### ADDENDUM 1

CSP 22-92

## Cavazos Elementary School Heating & Air Condition (HVAC) Improvements Funded through the Elementary & Secondary Emergency Relief (ESSER) Funds May 31, 2022

## Addendum

SHEET NUMBER: **E6.01**

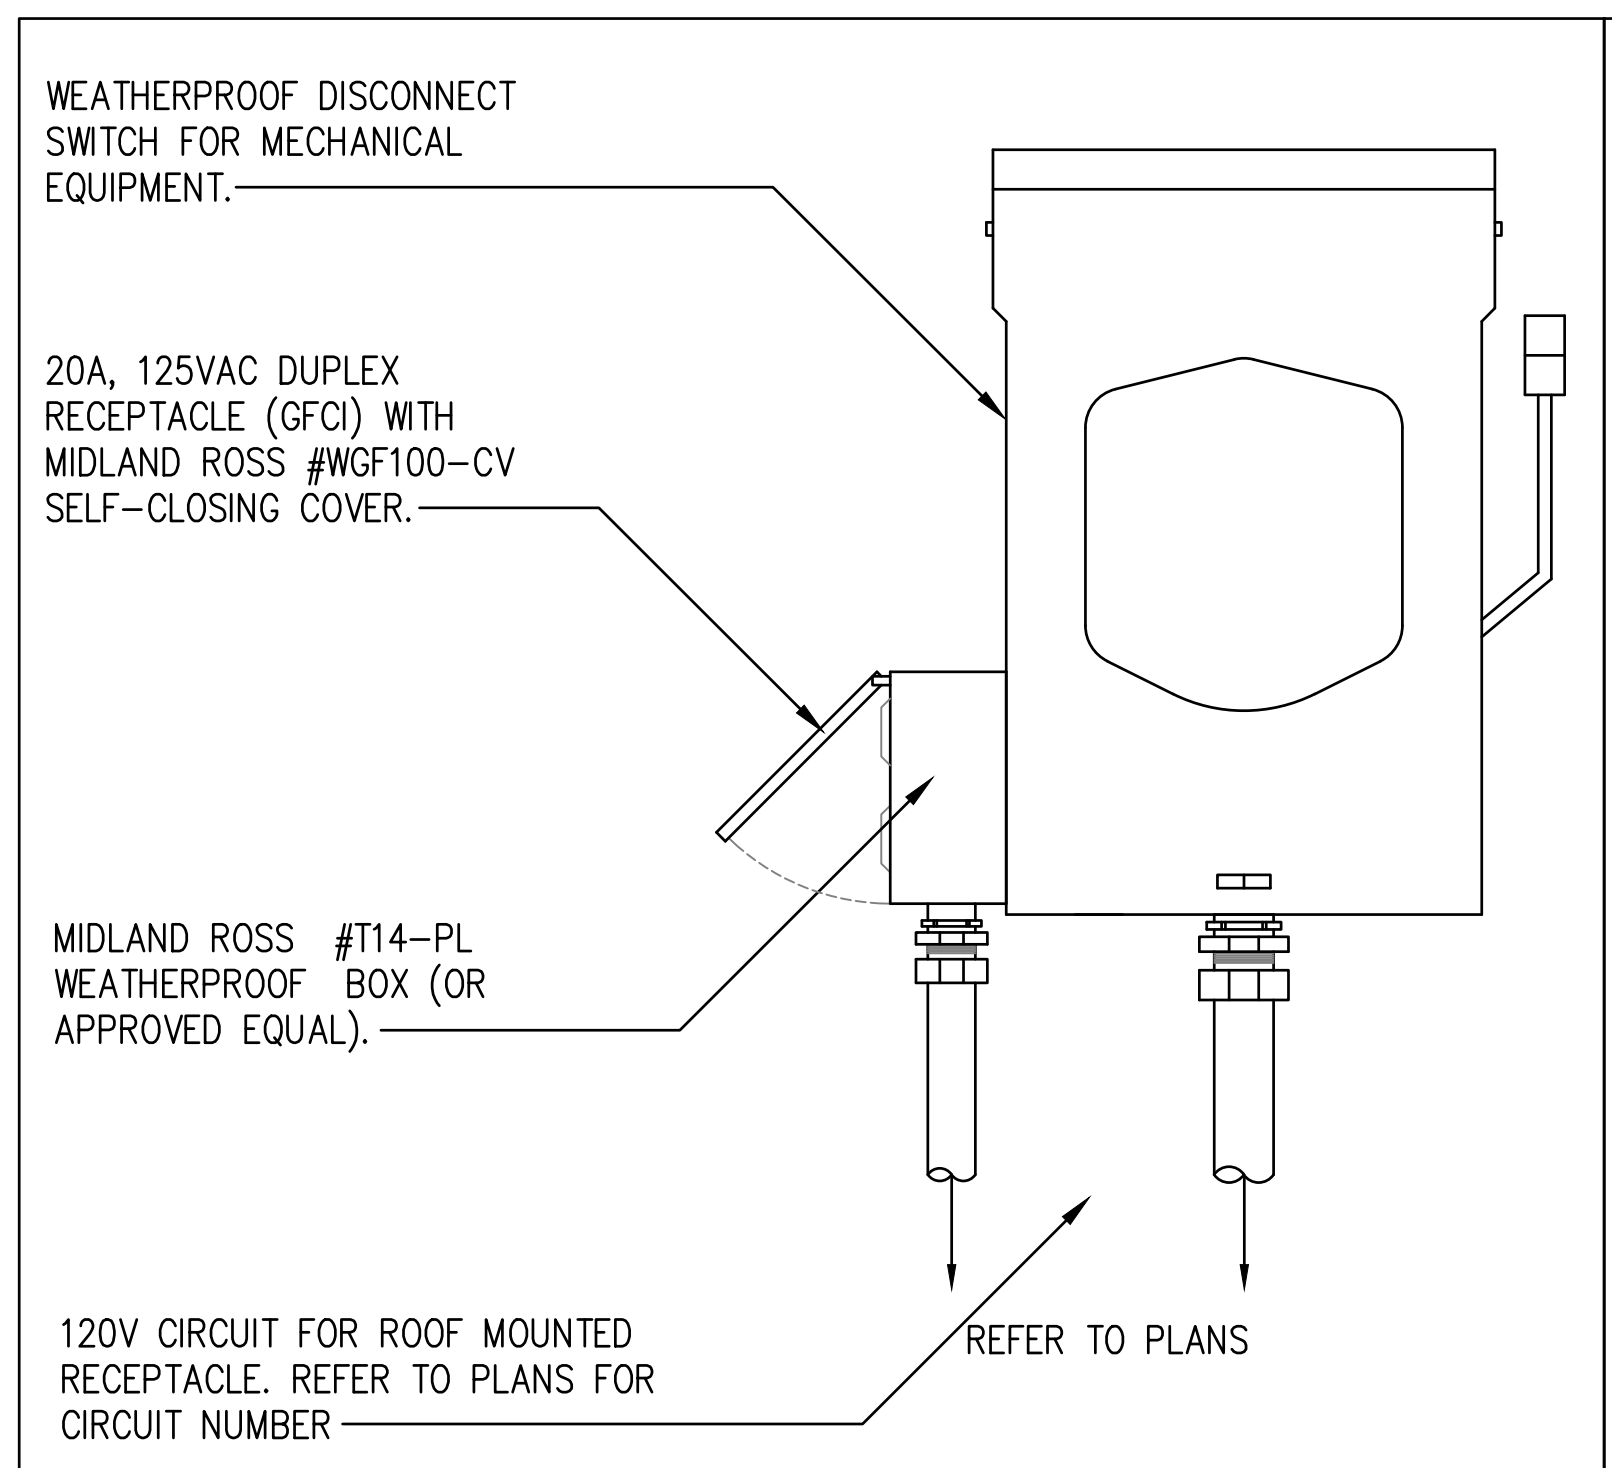
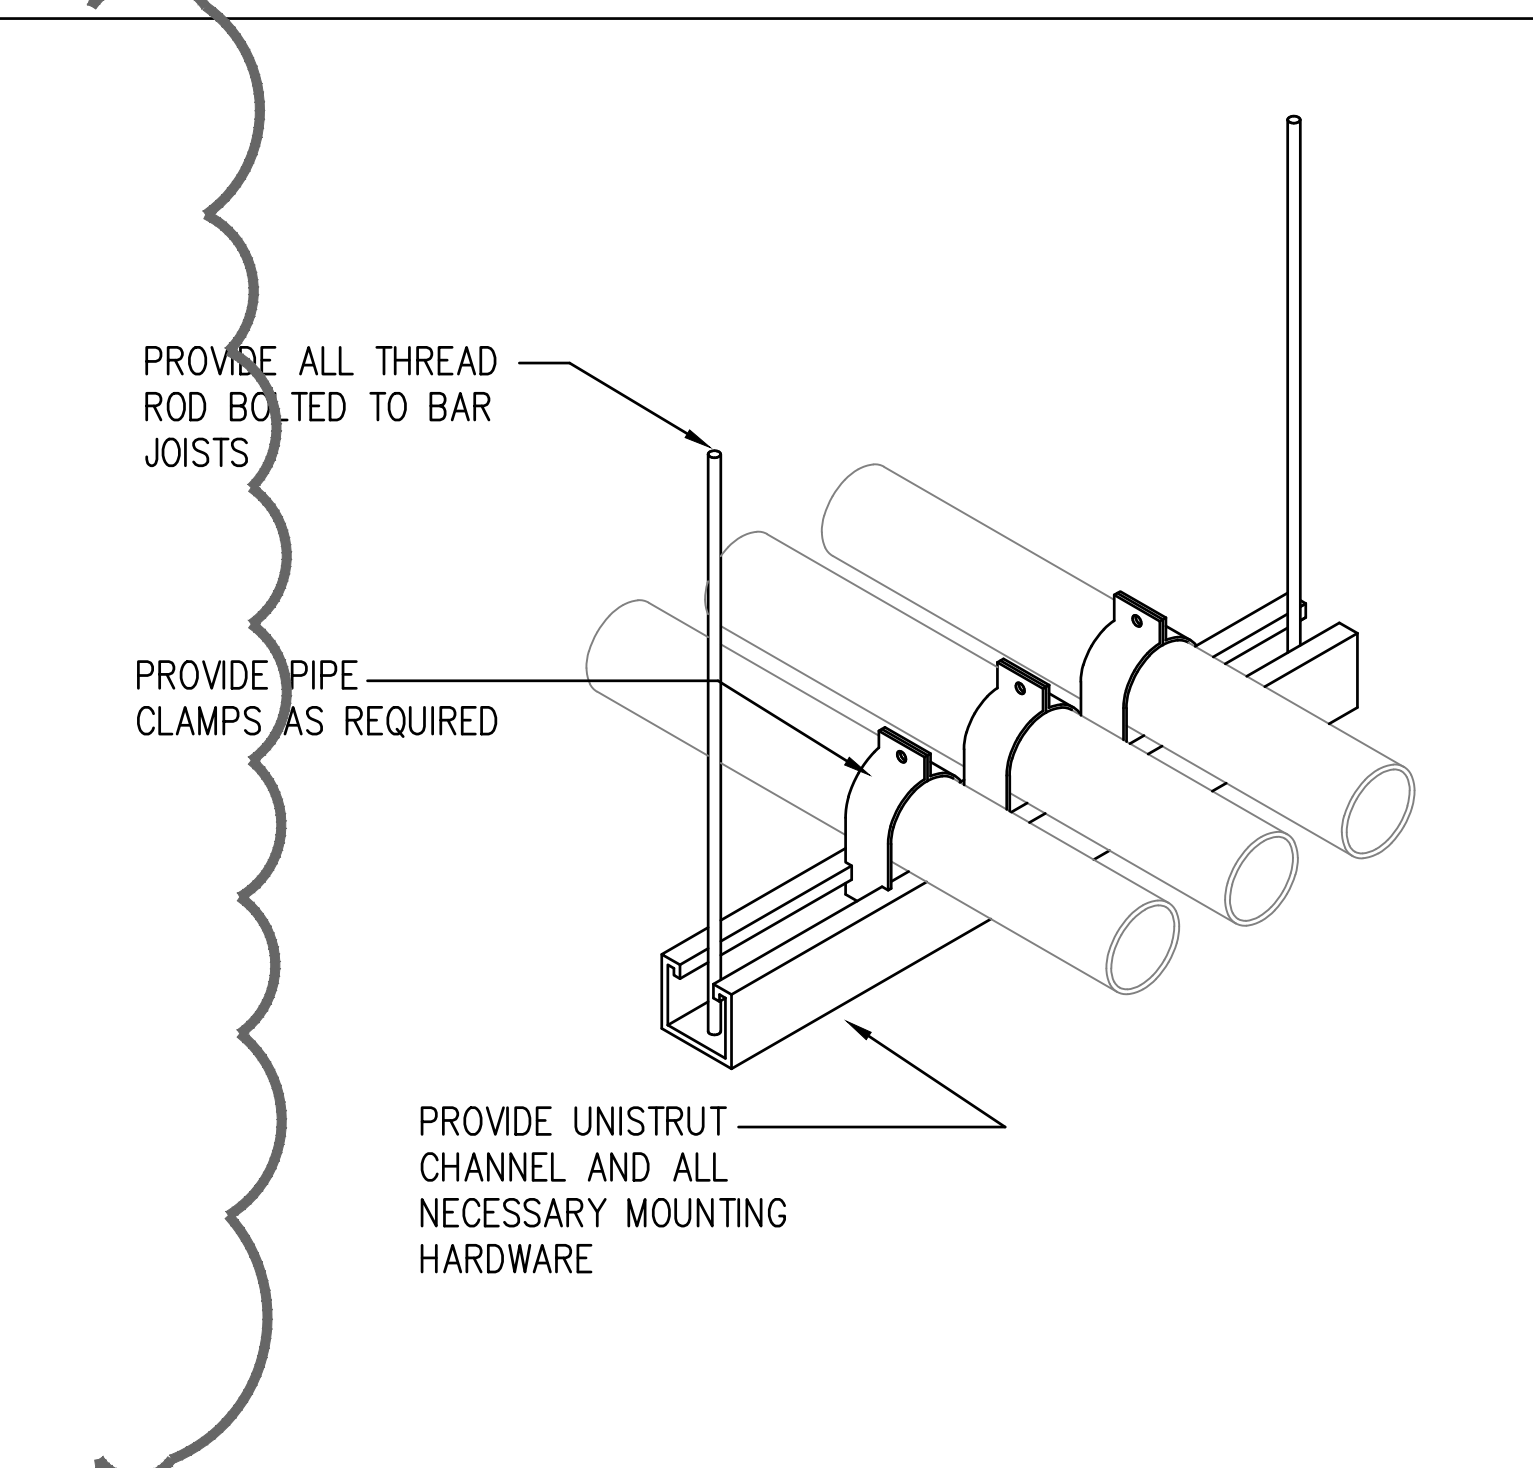
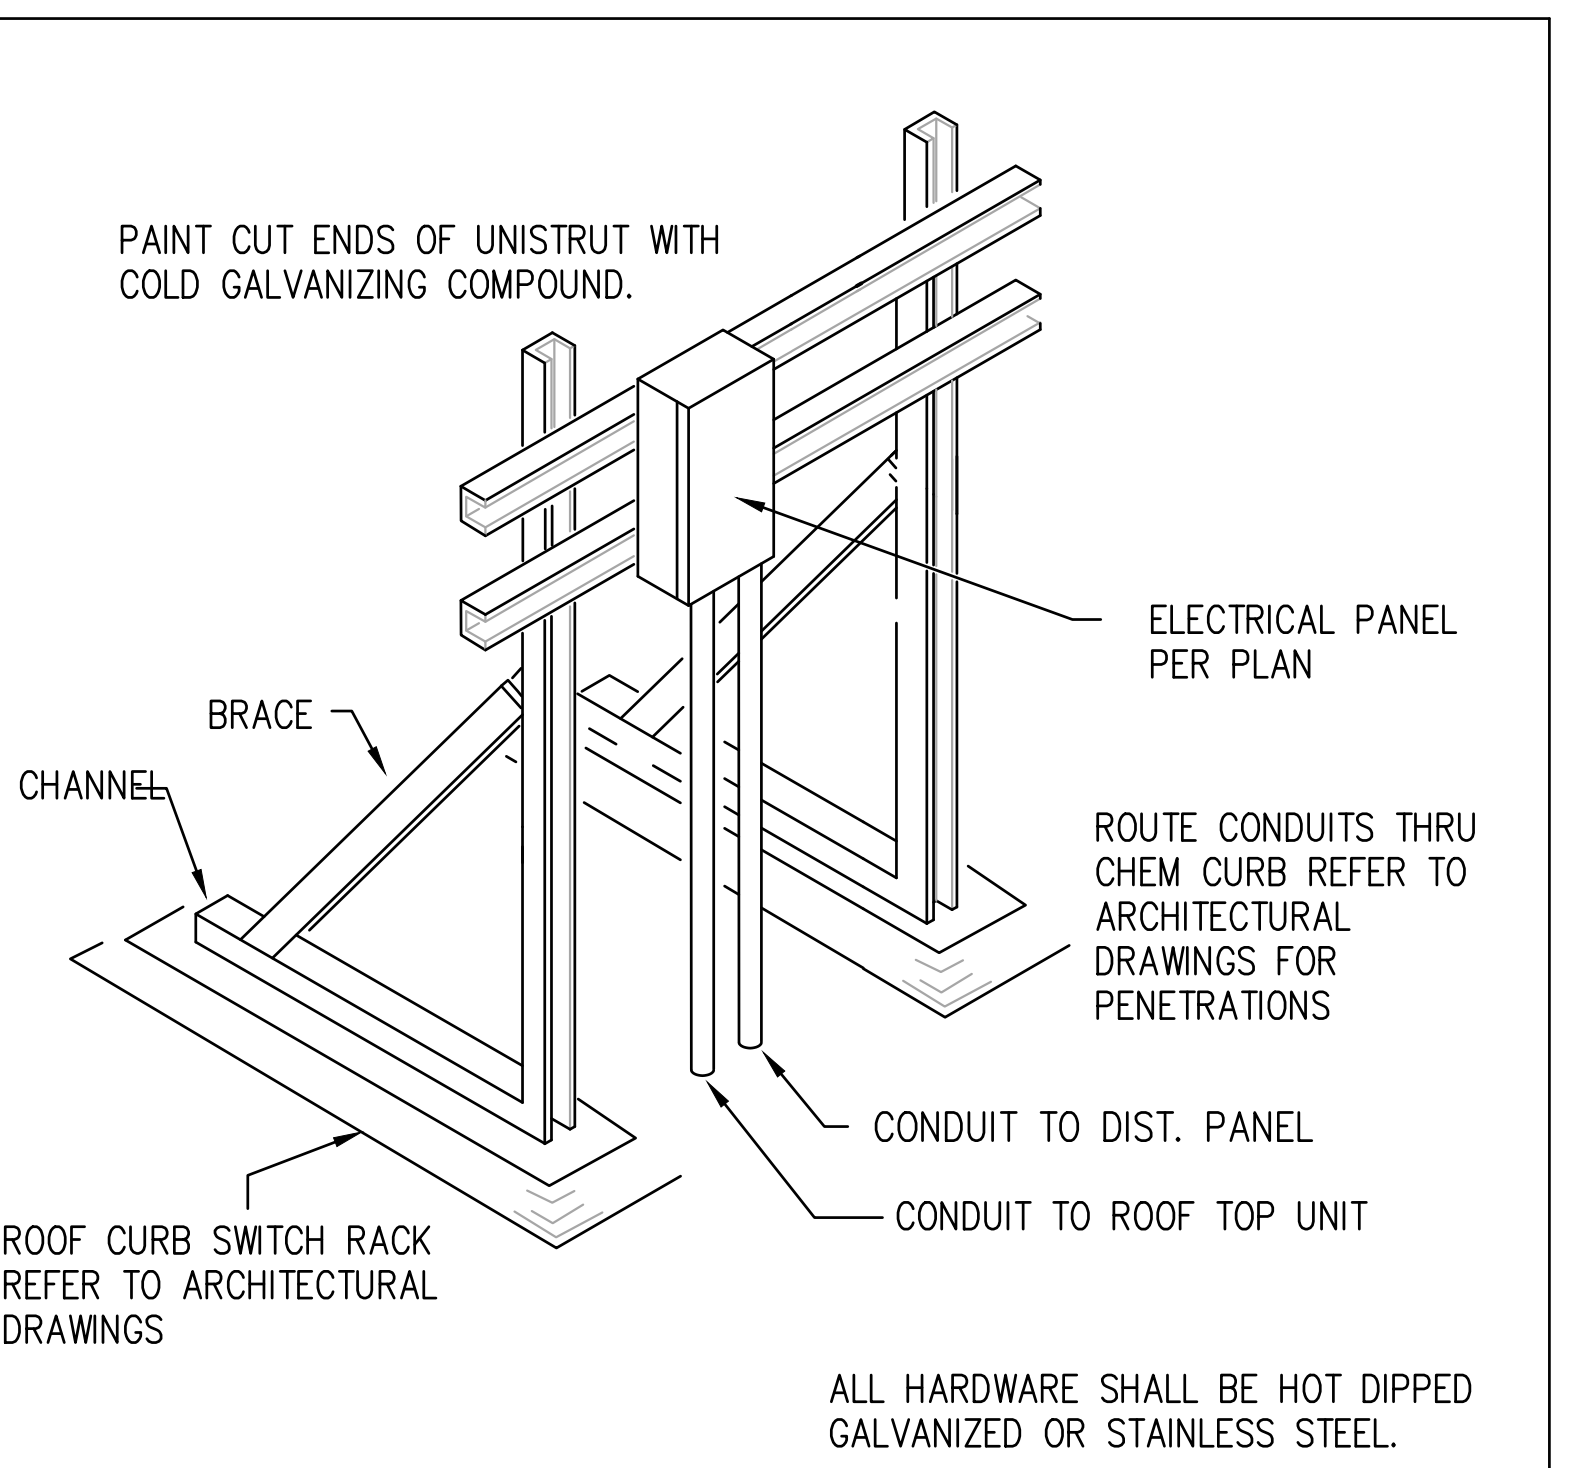
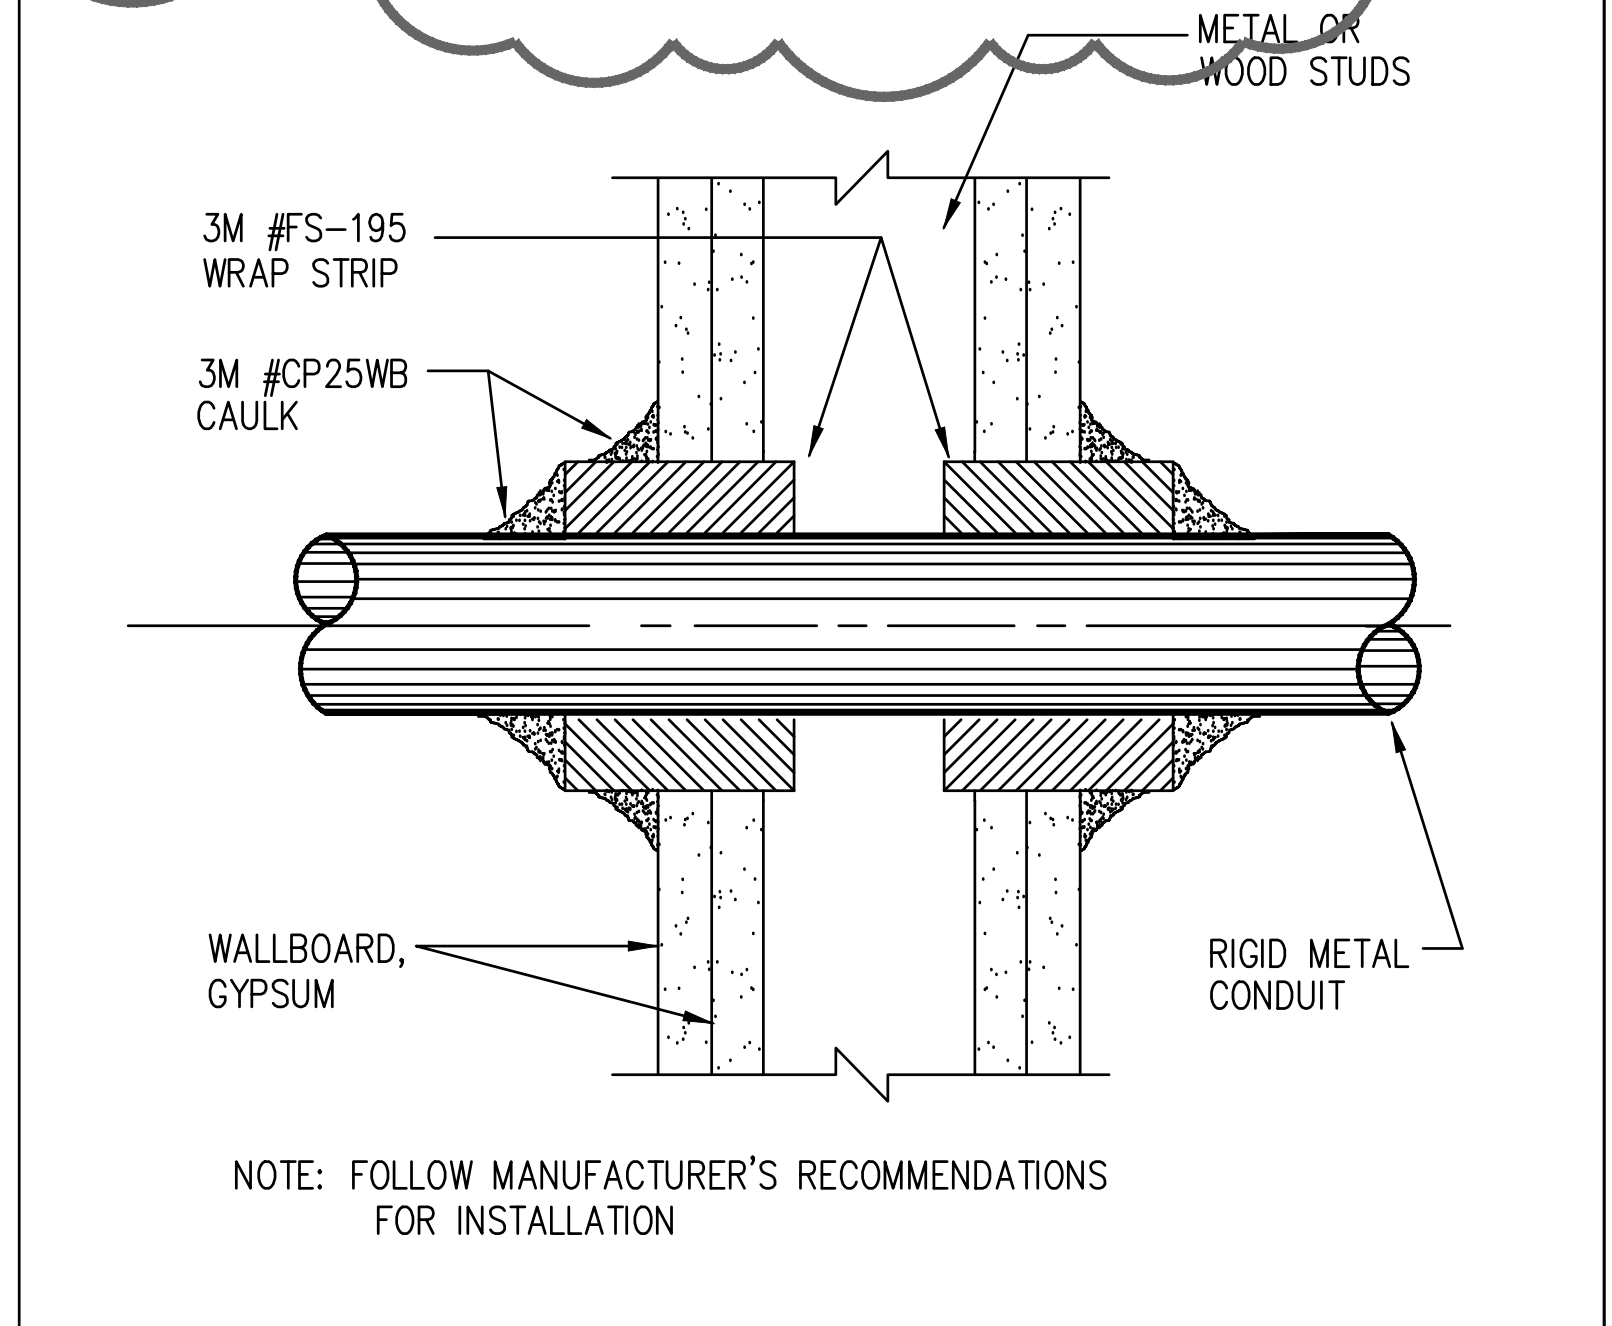
- A.     Added electrical detail.
- B.     Revised feeder schedule.
